2021 GROUP A PUBLIC COMMENT AGENDA

SEPTEMBER 21 - 28, 2021
DAVID L. LAWRENCE CONVENTION CENTER
PITTSBURGH, PA

2021 Public Comment Agenda

FIGURE 1207.11.7.1 ESS VEHICLE IMPACT PROTECTION

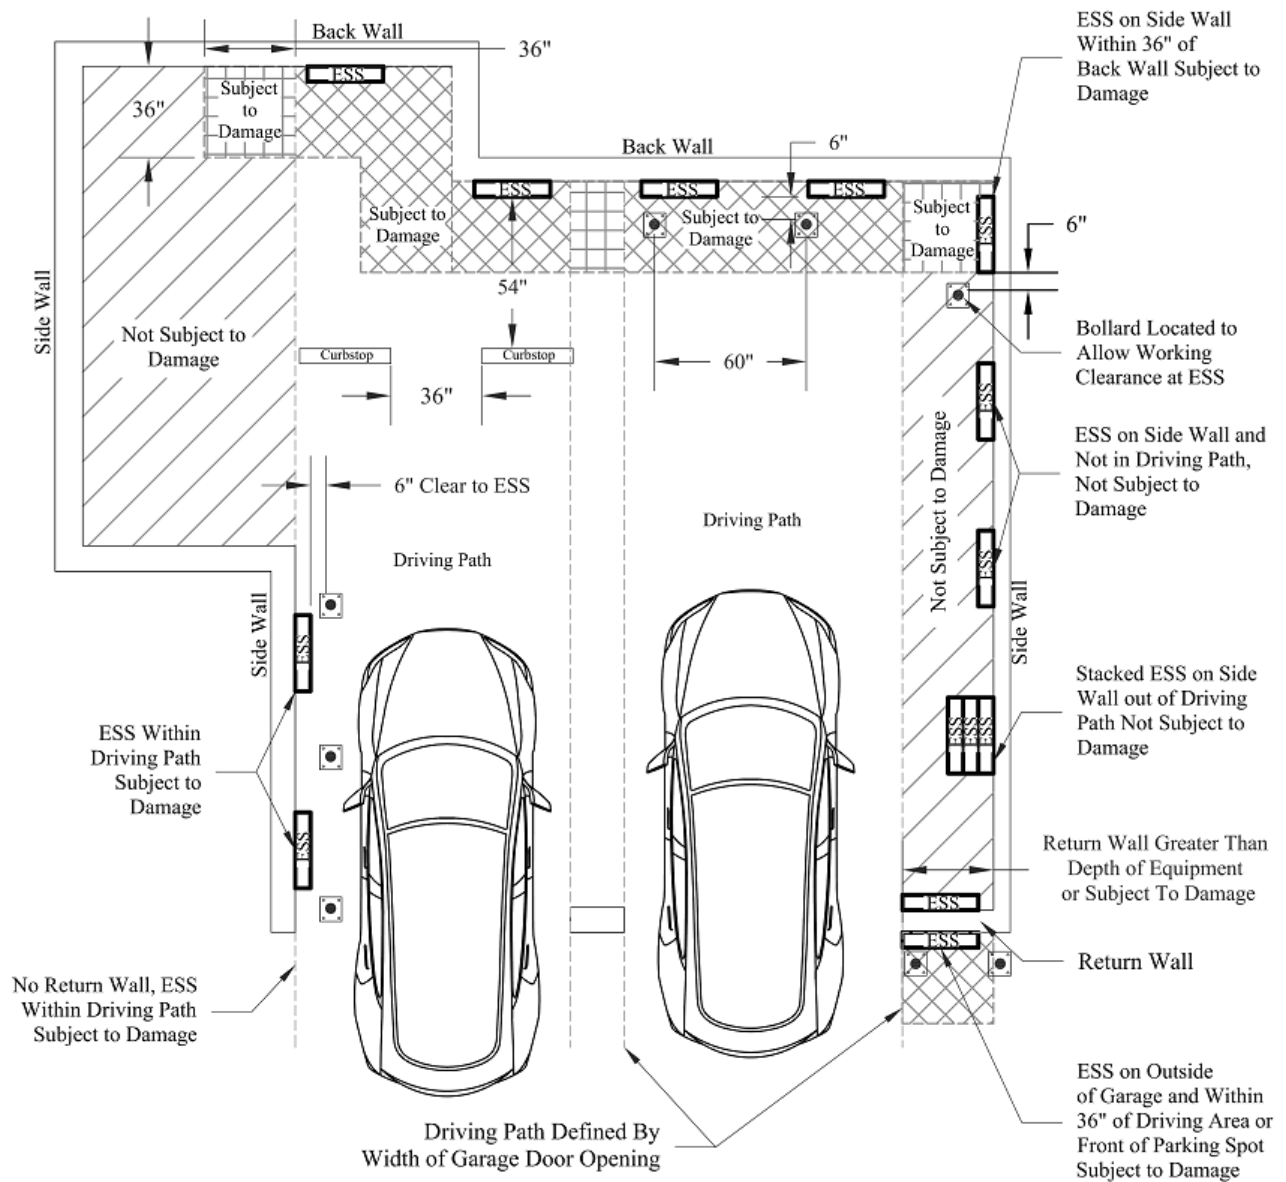
- A new Figure 1207.11.7.1 has been added to illustrate the zones in which a typical residential garage ESS installation would trigger the need for impact protection. This figure is based on existing IMC commentary related to the installation of fuel-fired appliances that may pose a fire hazard when damaged. The IMC commentary Figure 304.6 (2) has been modified to reflect common ESS installation locations and takes a similar approach to mitigating the risk of impact.
- New language (1207.11.7.2) has been added to address other than garage locations that may also have vehicle access such as residential driveways, and also allows some flexibility to the AHJ and installer for larger, non-typical, or custom residential garages where the normal path of vehicle travel falls outside of the area defined in 1207.11.7.1.

FIGURE 1207.11.7.1 ESS VEHICLE IMPACT PROTECTION

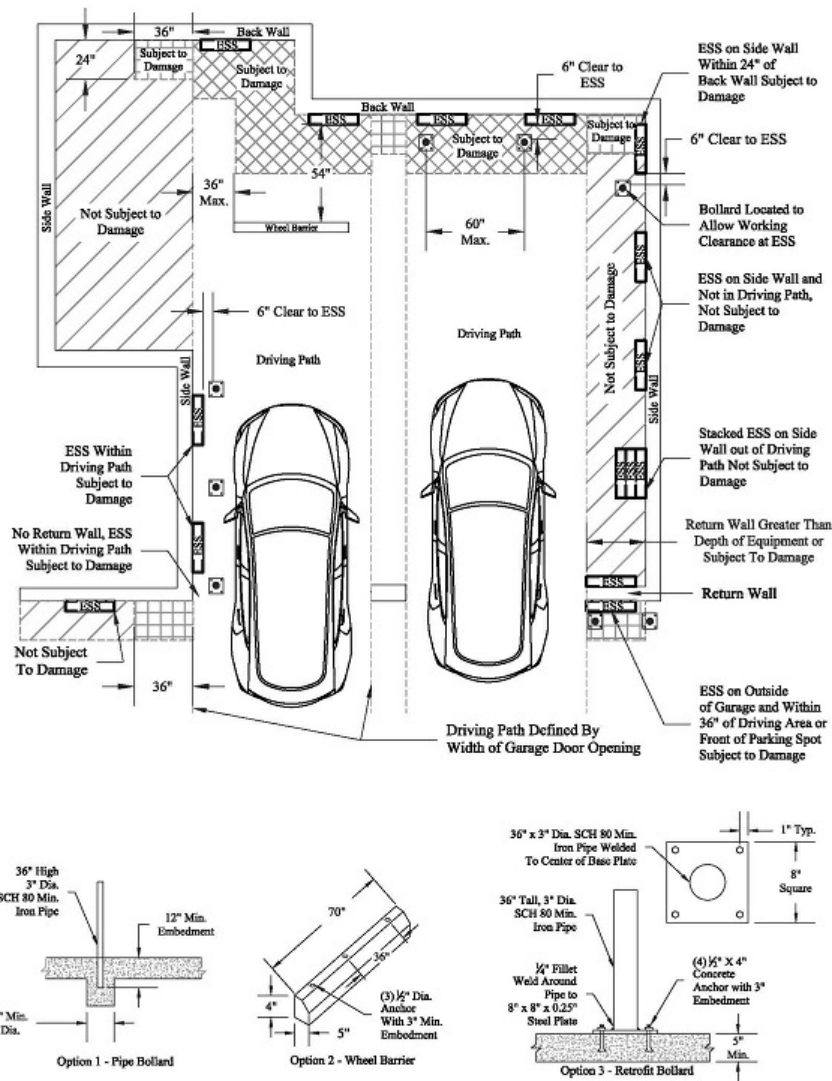
Commenter's Reason: This public comment is intended to address the following improvements, developed in collaboration between a SEAC working group and NAHB:

5. Further refine Figure 1207.11.7.1:
 1. Add an ESS on an exterior wall not subject to damage as an example
 2. Align terminology - replace "curb stop" with "wheel barrier"

Figure 1 - Example of the Intent

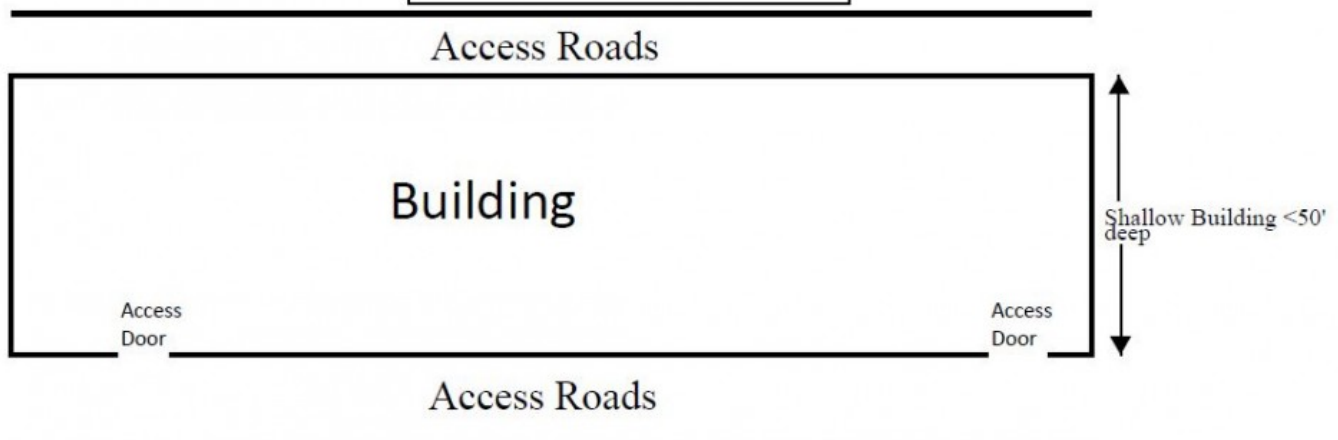
Reason: Please see Figure 1 below as an example of what the intent of this code change is. The language as it's currently written is impractical for the following reasons:

Figure 2 - Conflicts

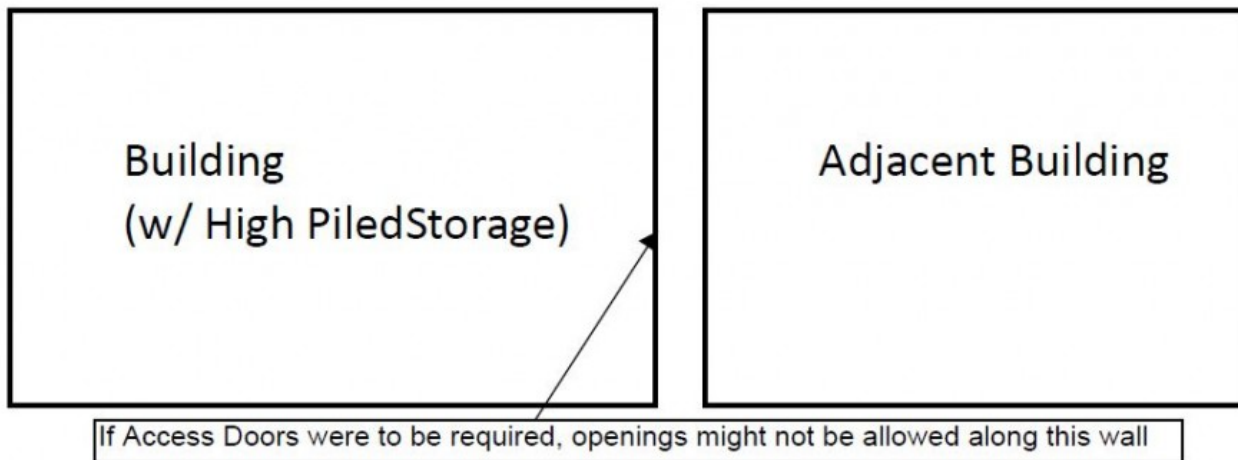
4. If the side of the building that does not require access roads abuts another building, then in many cases openings are not allowed along that side of the building, thereby creating a conflict in the code. Please see Figure 2 below as an example.

4005.2.3.6(5) IN-RACK SPRINKLER LAYOUT FOR MULTIPLE ROW RACK OF ON-END WOODEN BARRELS

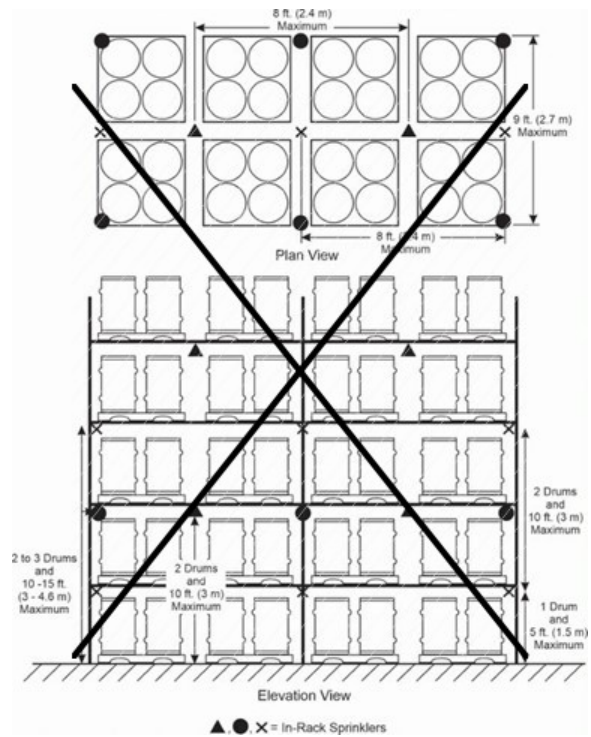
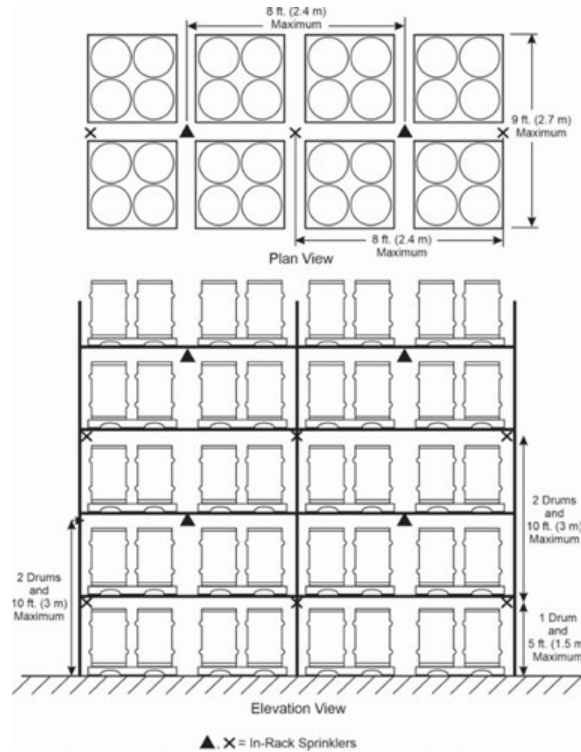
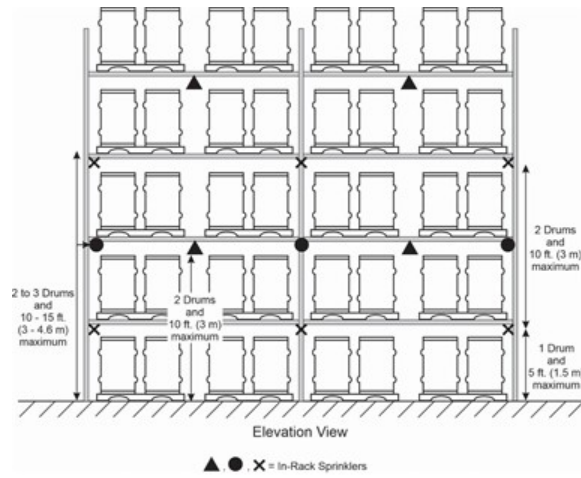
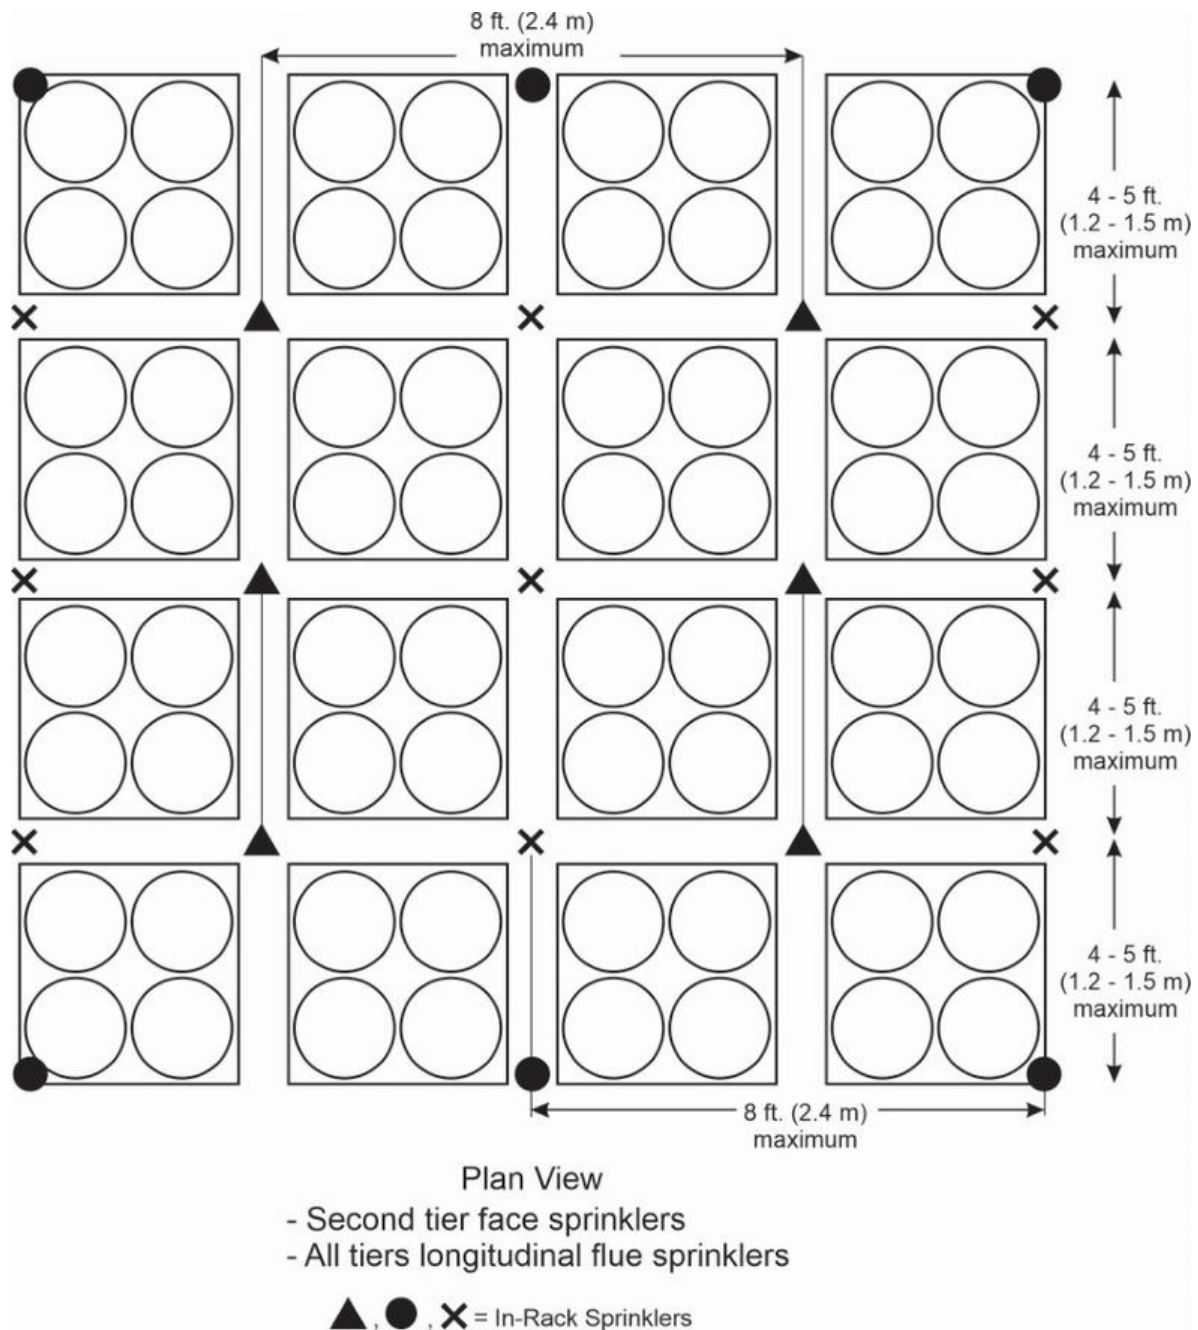
Commenter's Reason: The purpose of this PC is simply editorial. First it removes an unnecessary Figure from the table and the proposal. Additionally, the plan view of what is now numbered as Figure 4005.2.3.6(5) was omitted in the original proposal and has been added by this PC.
